From: Turpin, Paul [PTurpin@trcsolutions.com]
Sent: Monday, February 27, 2012 1:24 PM
To: Sylvester, Kathy M - DNR
Cc: 'John Liddicoat (John.Liddicoat@exopack.com)'
Subject: RE: Clarification on "developing on a historic fill"

PROJECT: PECHINEY PLASTIC PA 271 RIVER ST MENASHA, WIS

SHEET TITLE: SITE PLA

From: Turpin, Paul [mailto:PTurpin@trcsolutions.com]
Sent: Wednesday, December 14, 2011 05:19 PM
To: Sylvester, Kathy M - DNR
Subject: Demo Wax Refining Building at Exopack 271 River Street, Menasha, WI

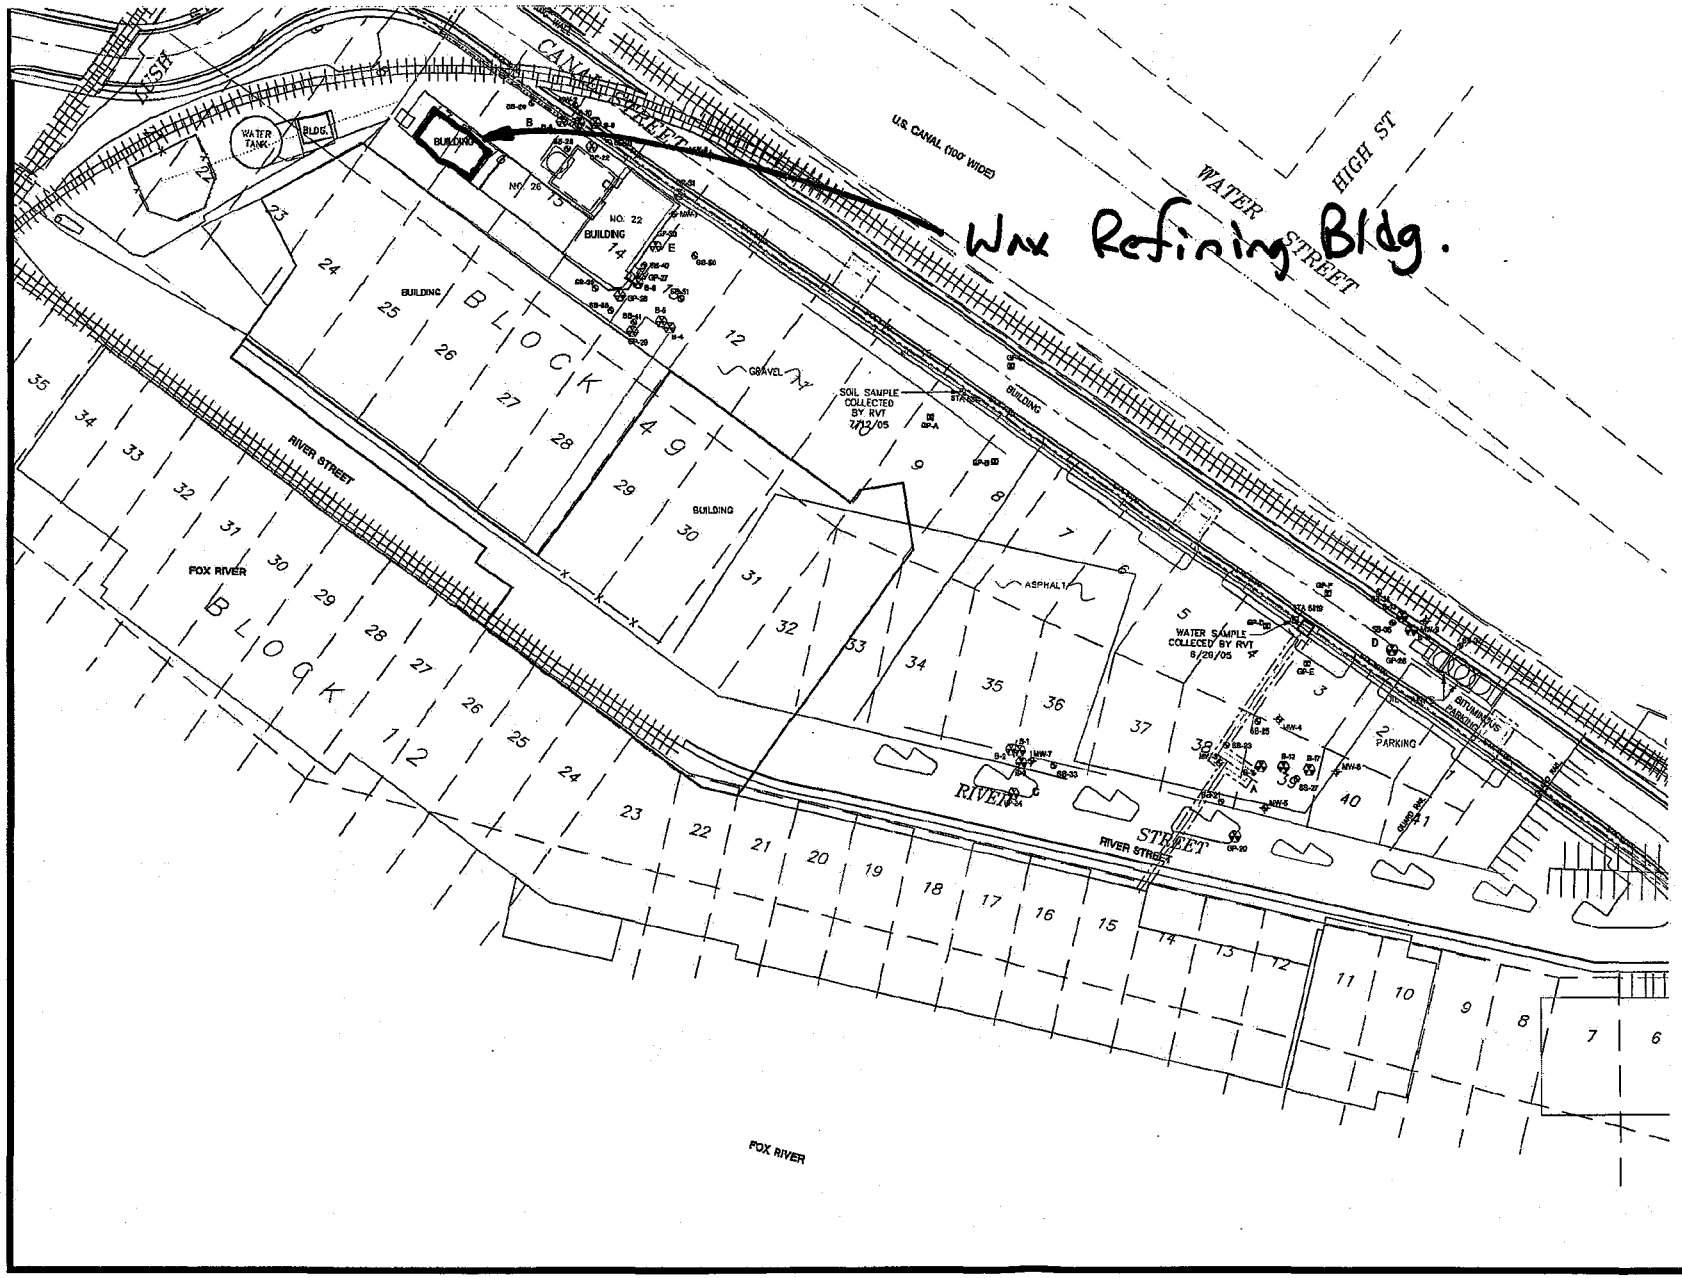
See attached drawing. Let's see if this helps. There is no stack or boiler on this property.

Hi Paul, found several references. We are talking about the boiler house and smokestack correct?

In addition, please note that the restricted areas are also areas where fill material was brought in. If this area is ever to be built on, a historic fill exemption will need to be granted. The Remediation and Redevelopment program can grant these exemptions with the proper information, forms, and fee submitted to the program.

Second, the cap includes the smokestack and the entire building, so when you want to remove that building you are in essence removing part of the cap. This is also stated in the letter.

and we come full circle....back to "no you do not need to apply for a historic fill exemption"...here's why...
1) there are no cap requirements in this area, even though there is a corridor along the river that has waste fill, the wax building area was not investigated for the presence or absence of fill.
2) to avoid finding out that there is "waste fill", Exopach's plan to leave the foundation, fill with clean soil, and pave over the area is a good idea.

Documentation of the plans and implementation (photos, etc) are always greatly appreciated to make a more complete file in the department records.

SHEET TITLE: SITE PLAN

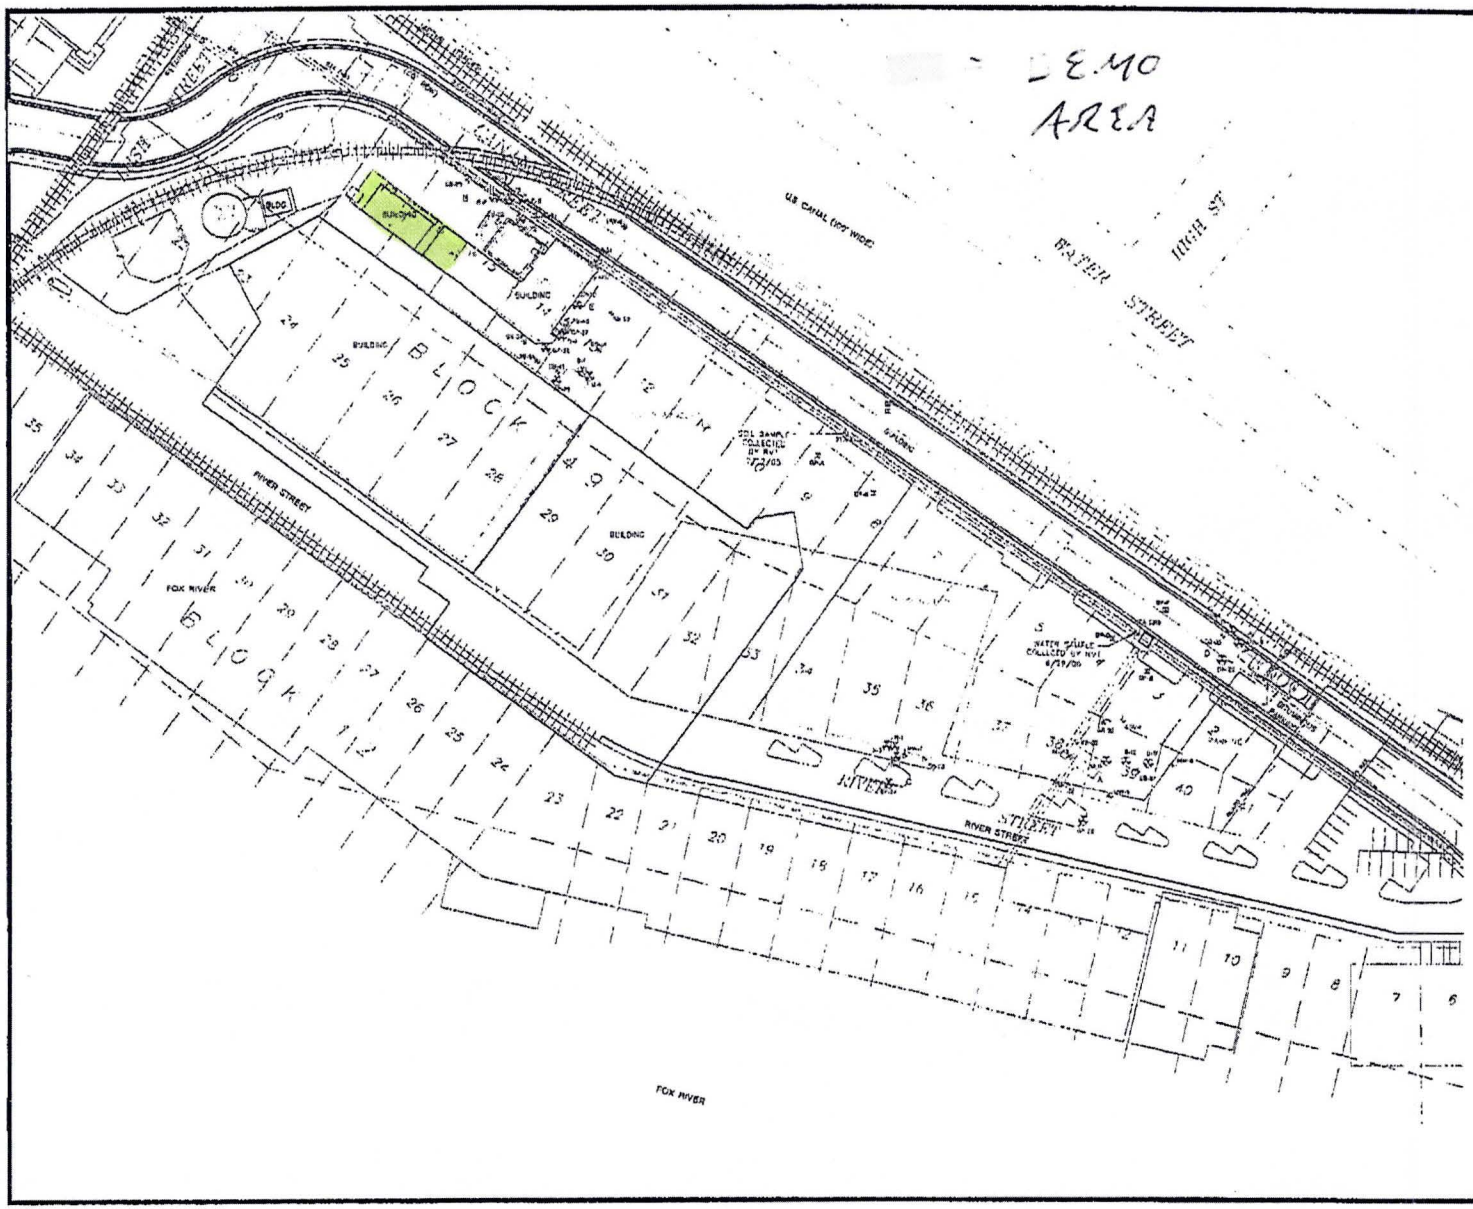
Kathy, attached is the drawing showing the location of the building to be demo'd. It is approximately 30 feet by 80 feet. It would be taken down to the ground, but no excavation is planned below grade and no soils will be removed. Structural fill would be added within the foundation and then the area will be paved. The demo work would occur this winter and the paving next spring.

I understand that a Historic Fill Exemption would not be required if no fill is disturbed. Exopack will update the site figure in the cap maintenance plan to show the new area to be paved.

Will this satisfy as an adequate description, or does the DNR require a formal letter with drawing for your files? We are happy to do that.

The demo area is marked in yellow. Any questions, please let me know. Thanks.

Not necessary, all good unless they end up 'digging' into their 'cap'.
